Mitigation Plan

Lake Wendell Mitigation Project

FINAL VERSION

Addendum to Mitigation Plan

SHEET NAME
R2&R3
PLAN AND PROFILE
 SHEET NUMBER
10

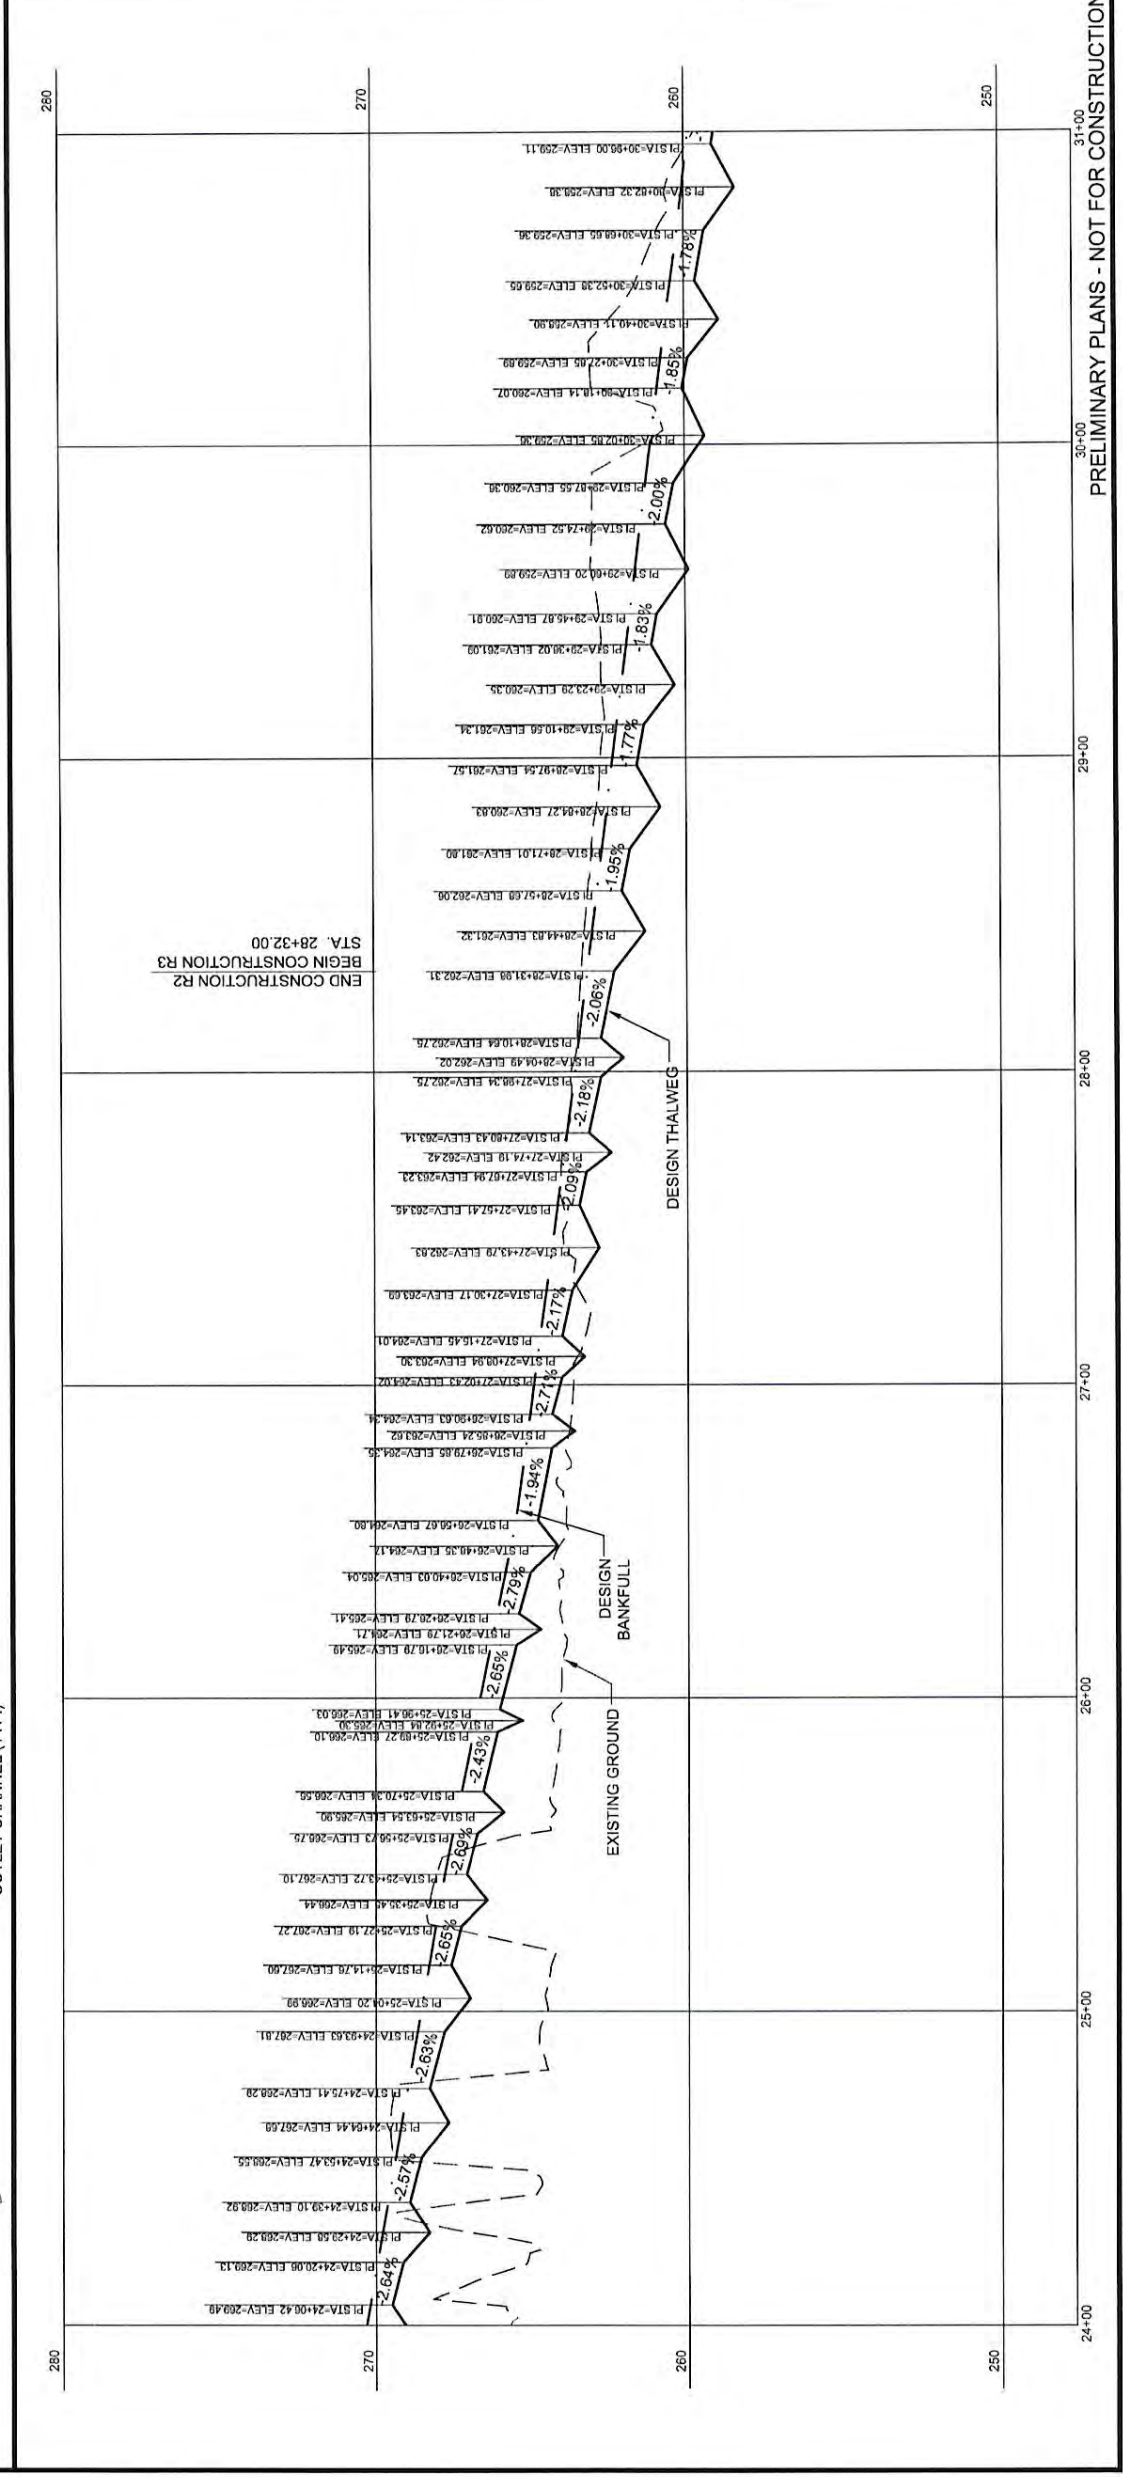
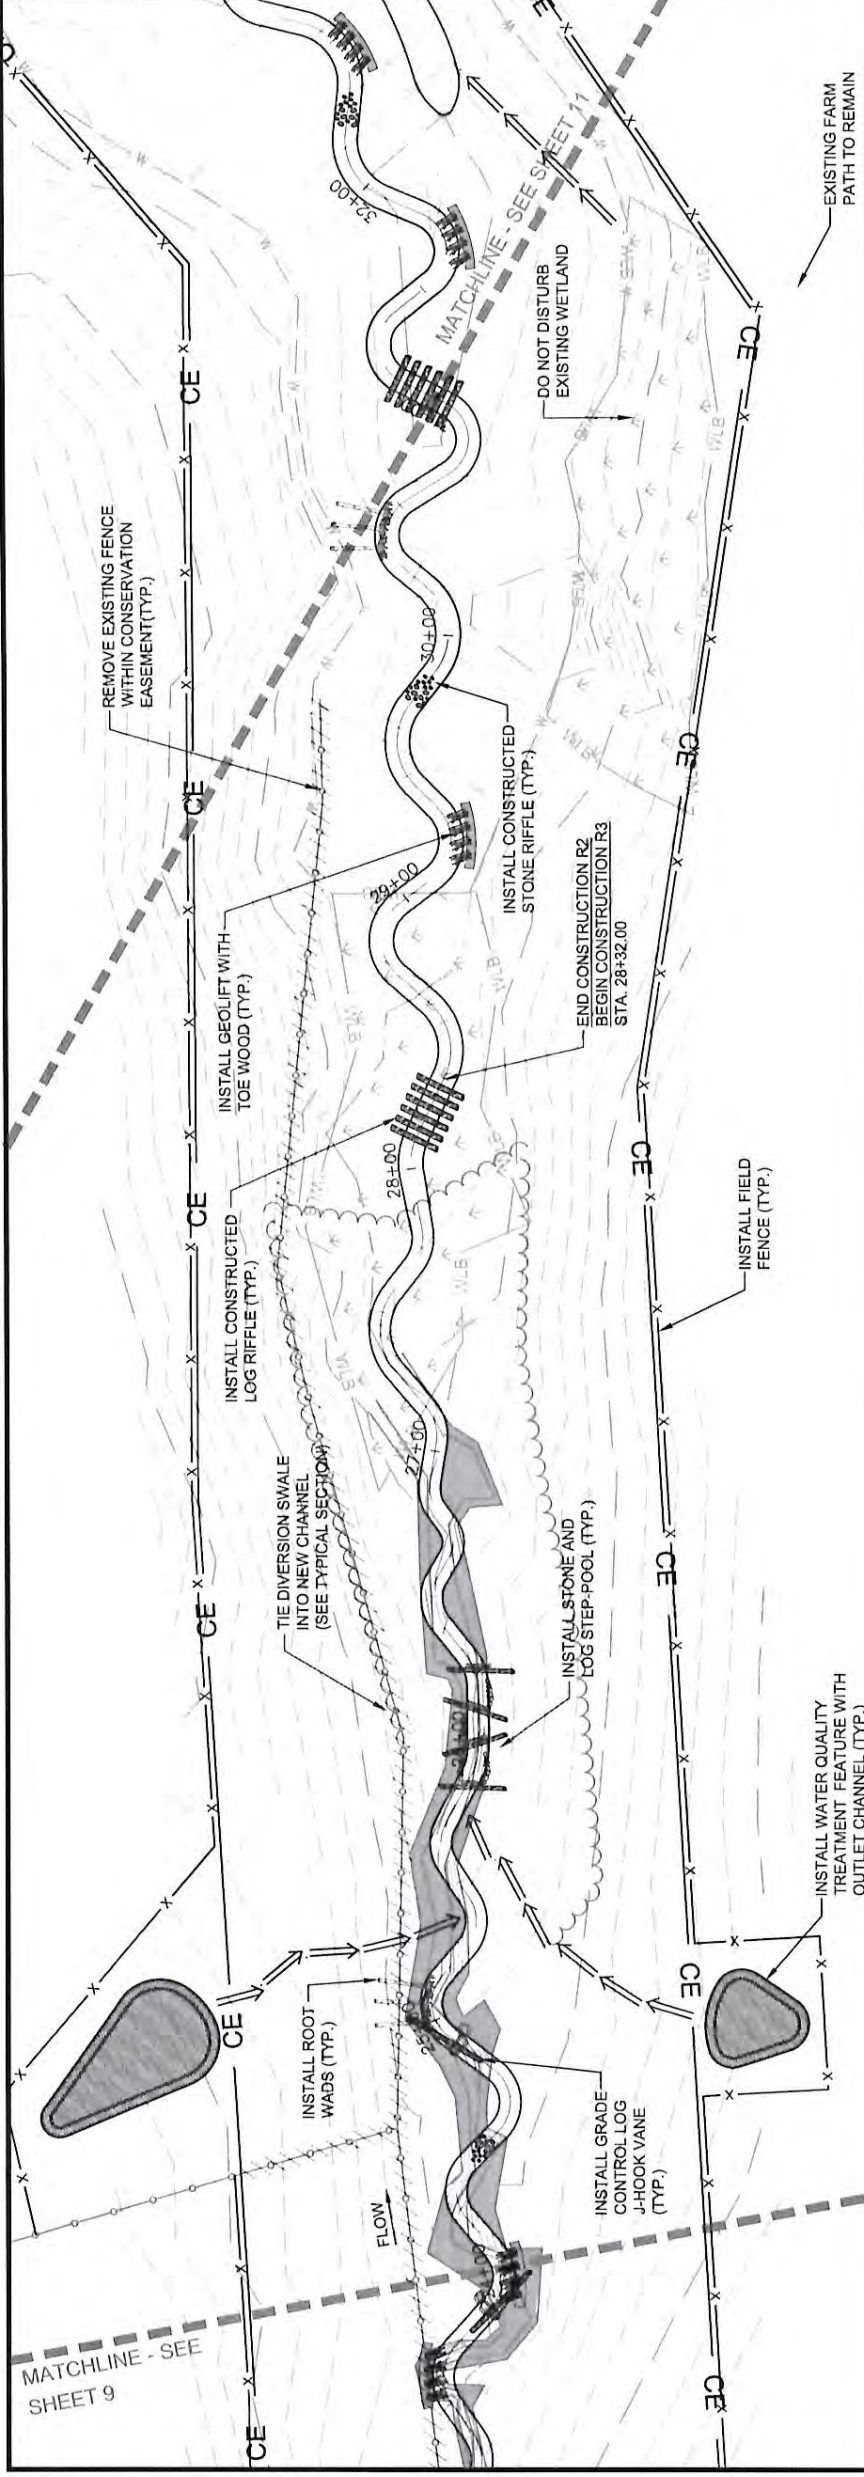
9. DWR likes the depressional water quality features, however, for those features outside of the easement, how will they be protected? Managed?
10. For the water quality features located outside of the easement, Design sheets 9 and 10 show that these features will include an outlet channel which shows it discharging down to the stream. DWR would prefer that the outlet channel discharge into a mounded level spreader somewhere in the riparian buffer so the flow will have a chance to dissipate before entering the stream. Or these channels could discharge into a constructed vernal pool which would then dissipate the flow energy from the outlet channel.

10. For the water quality features located outside of the easement, Design sheets 9 and 10 show that these features will include an outlet channel which shows it discharging down to the stream. DWR would prefer that the outlet channel discharge into a mounded level spreader somewhere in the riparian buffer so the flow will have a chance to dissipate before entering the stream. Or these channels could discharge into a constructed vernal pool which would then dissipate the flow energy from the outlet channel. Response: WLS understands the concern of installing these outlet channel features that discharge into the regulated Neuse River buffer. The water quality treatment features and their corresponding outlet channels are proposed along non-jurisdictional flat or depressional areas where existing small ephemeral drainages (drainage areas ave. 3 to 7 acres) intersect with the proposed conservation easement/restored stream and riparian buffer corridor. The proposed outlet channels are intended to replace and improve the existing degraded ephemeral channels, at the same locations, to provide a stabilized connection to the restored stream system for the existing concentrated ephemeral flow path. It is anticipated that over a few growing seasons post-construction, these small conveyance swales will become heavily

SHEET NAME
R4
**PLAN AND
 PROFILE**
 SHEET NUMBER
13

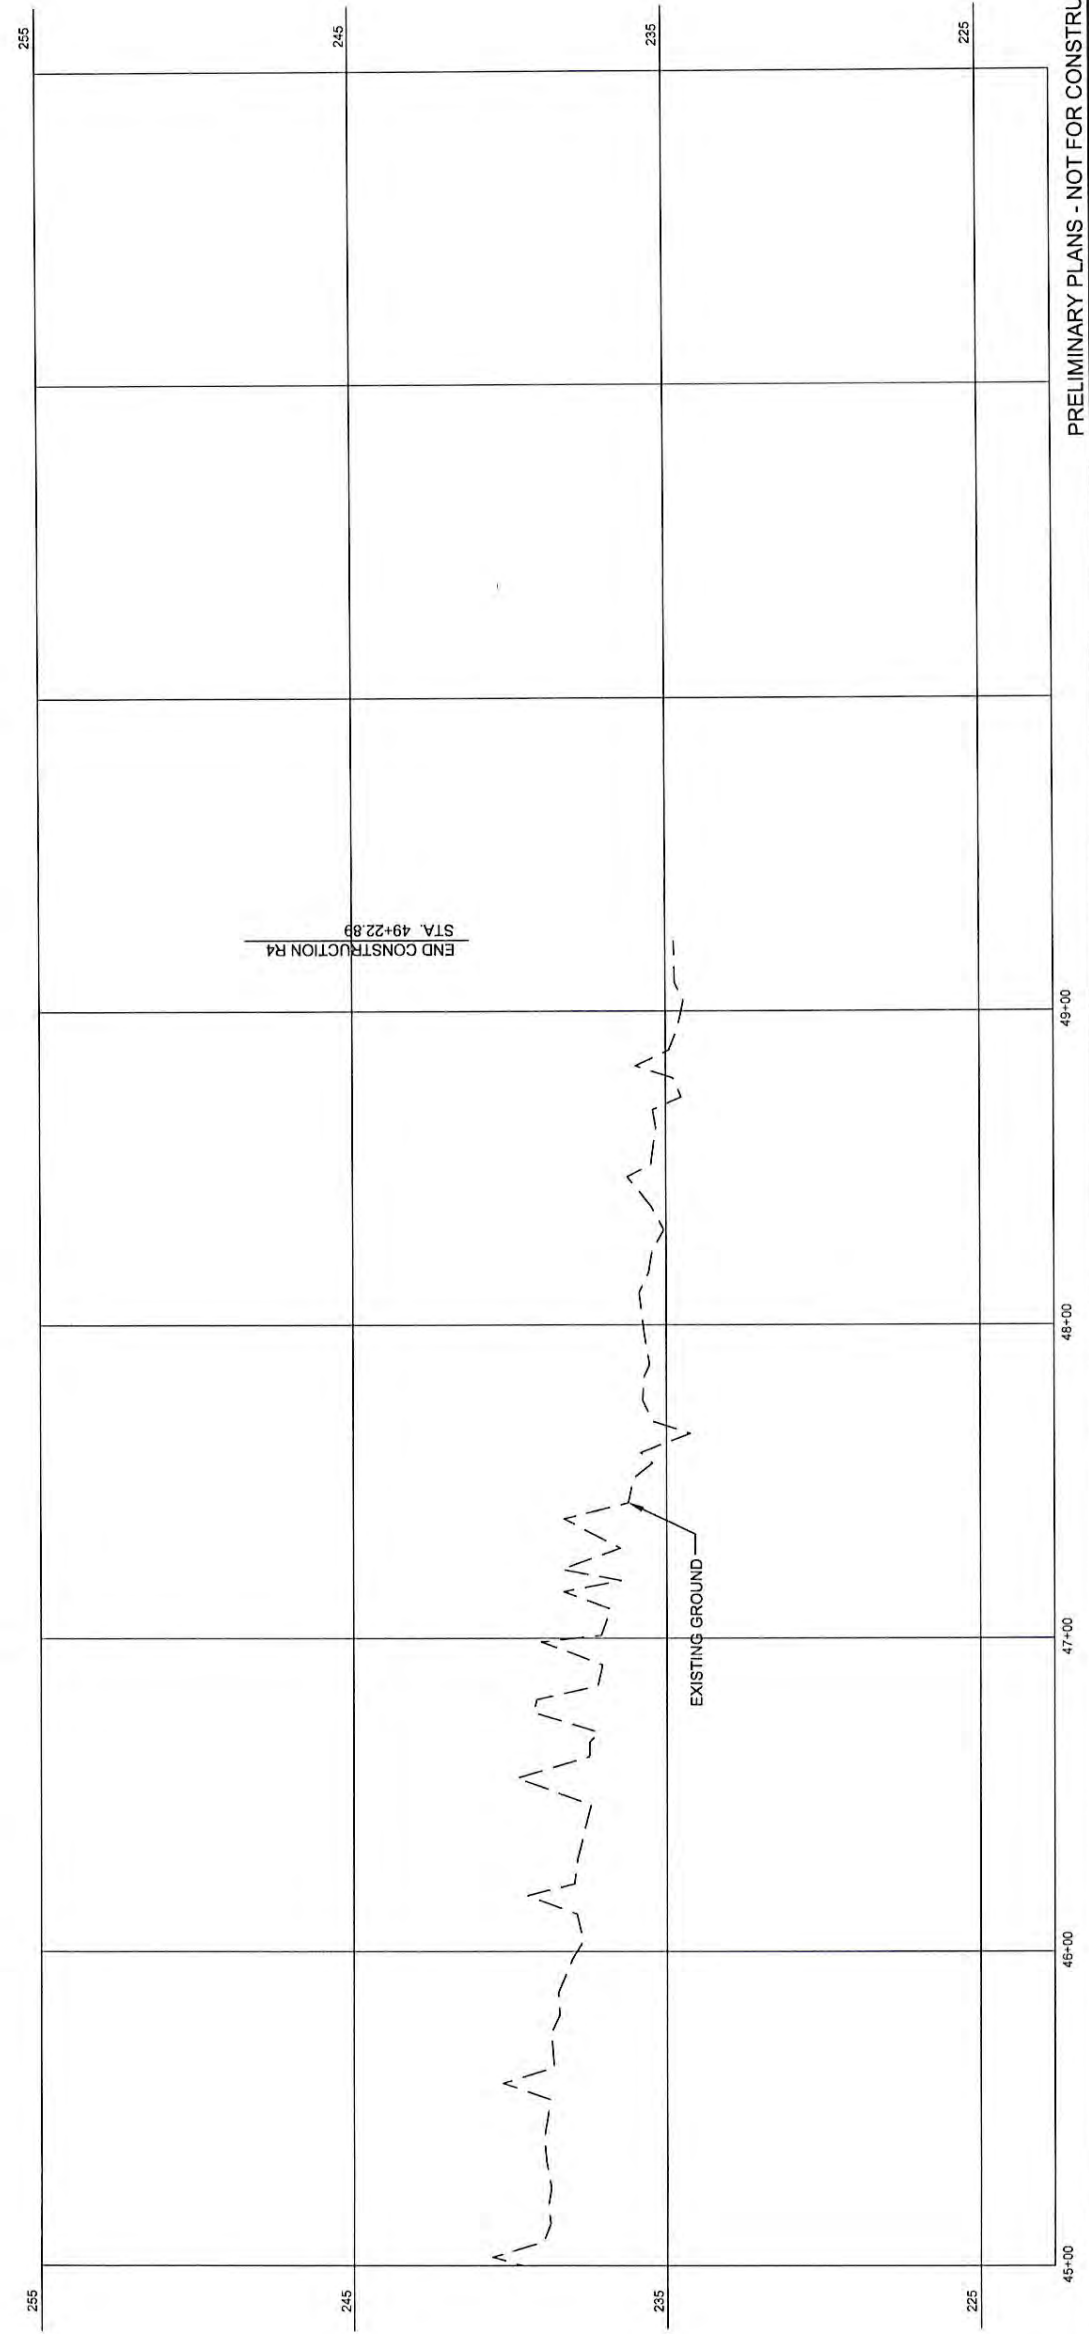
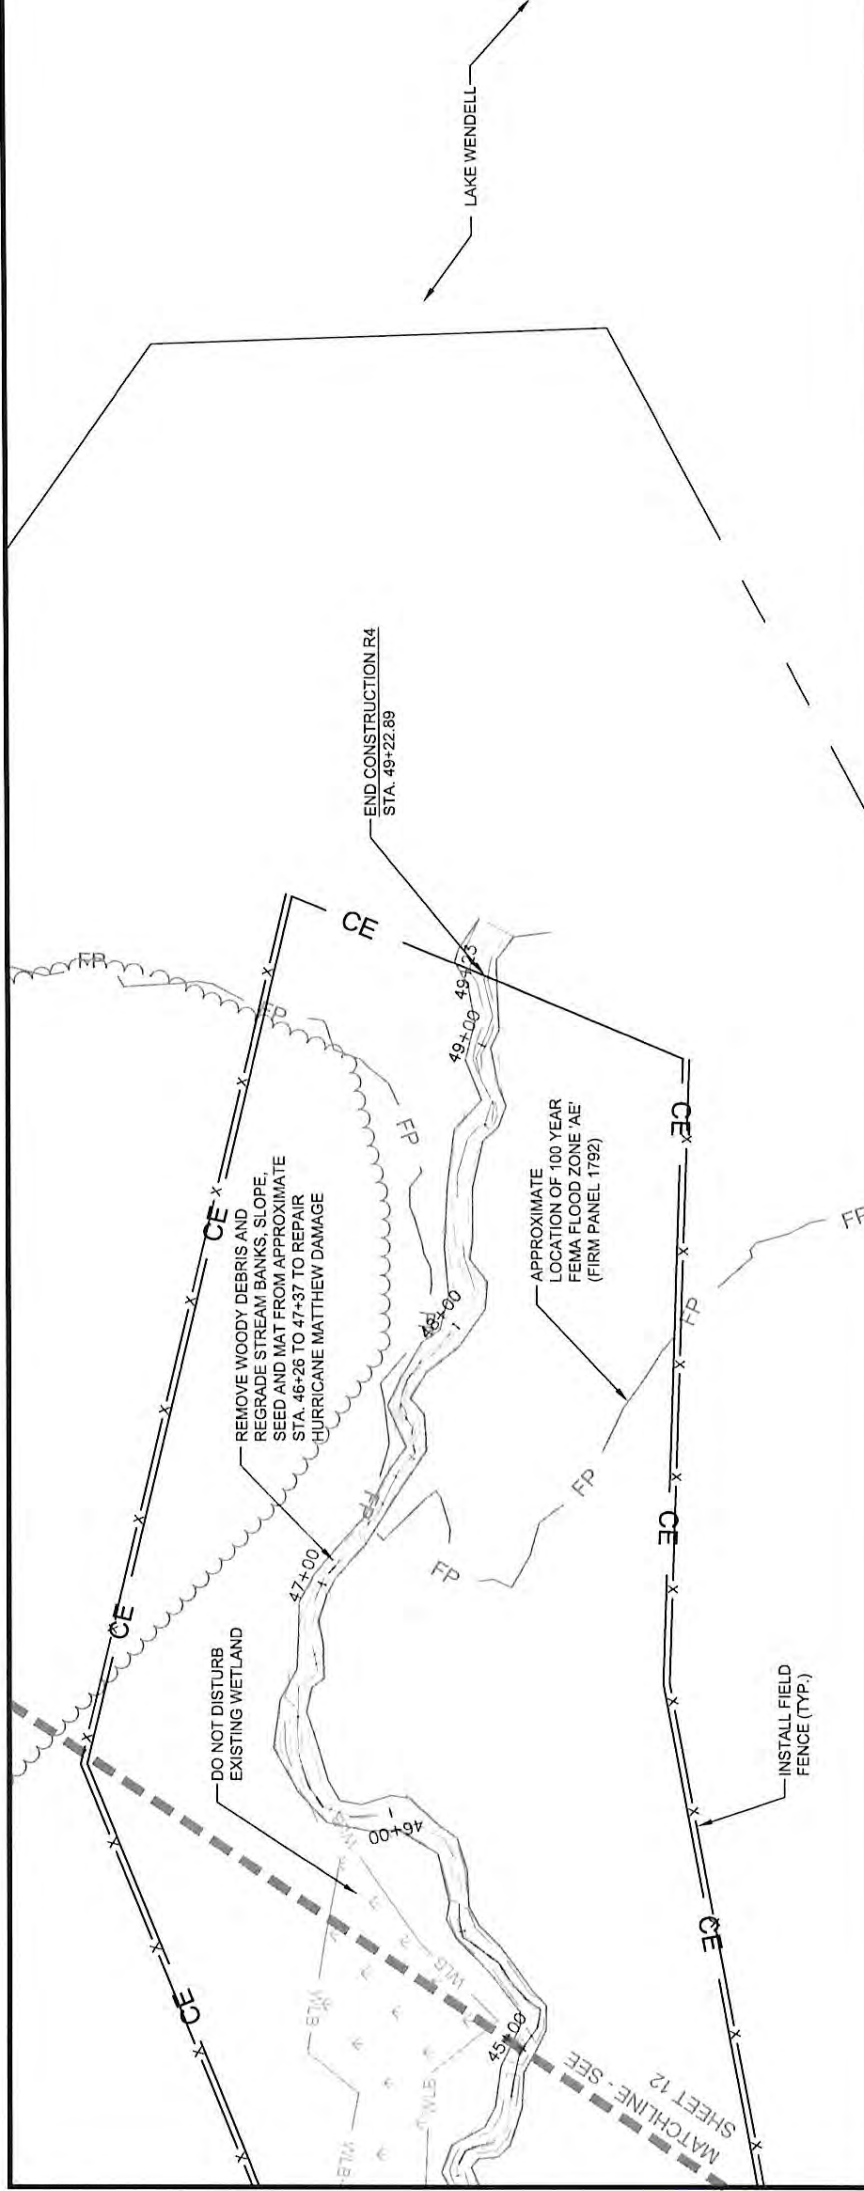
- On Plan Sheet #13, a portion of the Enhancement area on R1 appears to be less than 30'. I'm unable to confirm the proposal without seeing it visually represented where it can be provided.

- **On Plan Sheet #13, a portion of the Enhancement area on R1 appears to be less than 30'. I'm unable to confirm the proposal without seeing it visually represented where it can be provided.** WLS Response: Table 1, Figure 11, the Revegetation Plan (plan Sheets 15 through 18), and the appropriate mitigation plan text have been edited as suggested for clarification and to provide more transparency with regards to the proposed riparian buffer mitigation limits, ratios, and credits, and are included in the Final Mitigation Plan.
